# Access Compliance Report

### (Curb Ramps)

Intersection ID: 16783	Main Street: HAMPTON_AV	Cross Street: MALVERN_RD	Location: SW
ADA ID: 7561C87498FF	Ramp Type: PerpDiag	Initial Pass/Fail: Fail	Overall Compliance: No
Severity Score: 33.75			
Codes/Mitigation Info/Possible Solution		Field Measurements/Component Compliance

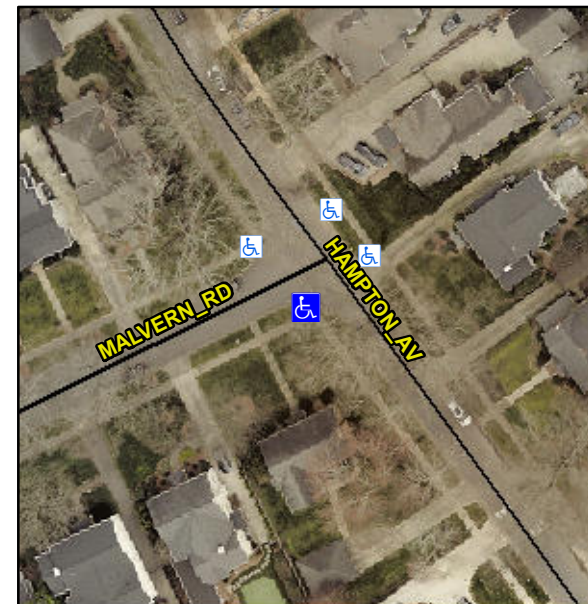
**R304.5.1, R304.5.3**

Compliance	Description	Data	Compliance	Description	Data
N/A	Ramp Length (in)	96.0	Yes	Ramp Slope (%)	7.0
No	Ramp Width (in)	39.0	No	Ramp XSlope (%)	9.7
N/A	Flare Type LT	N/A	N/A	Flare Type RT	N/A
N/A	Flare Slope LT (%)	N/A	N/A	Flare Slope RT (%)	N/A
N/A	Flare Traversable LT?	N/A	N/A	Flare Traversable RT?	N/A
N/A	Landing Length (in)	N/A	N/A	DWS Provided?	N/A
N/A	Landing Width (in)	N/A	N/A	DWS Contrast?	N/A
N/A	Landing Slope (%)	N/A	N/A	DWS Length (in)	N/A
N/A	Landing X Slope (%)	N/A	N/A	DWS Full Width?	N/A
N/A	Landing Curb? (Y/N)	N/A	N/A	DWS Offset (in)	N/A
N/A	Shared Landing?	N/A			
N/A	Gutter Ponding?	N/A	N/A	Gutter Slope (%)	N/A
N/A	Gutter Lip Ht (in)	N/A	N/A	Gutter X Slope (%)	N/A
N/A	Painted X Walk1?	No	N/A	Painted X Walk2?	No
	X Walk 1 Direction	To NE		X Walk 2 Direction	To NW
N/A	X Walk 1 Width (in)	N/A	N/A	X Walk 2 Width (in)	N/A
	X Walk 1 Slope (%)	0.2		X Walk 2 Slope (%)	6.3
	X Walk 1 X Slope (%)	6.4		X Walk 2 X Slope (%)	0.4

**Remove & Replace Curb Ramp With Two New Directional Ramps or Equivalent.**
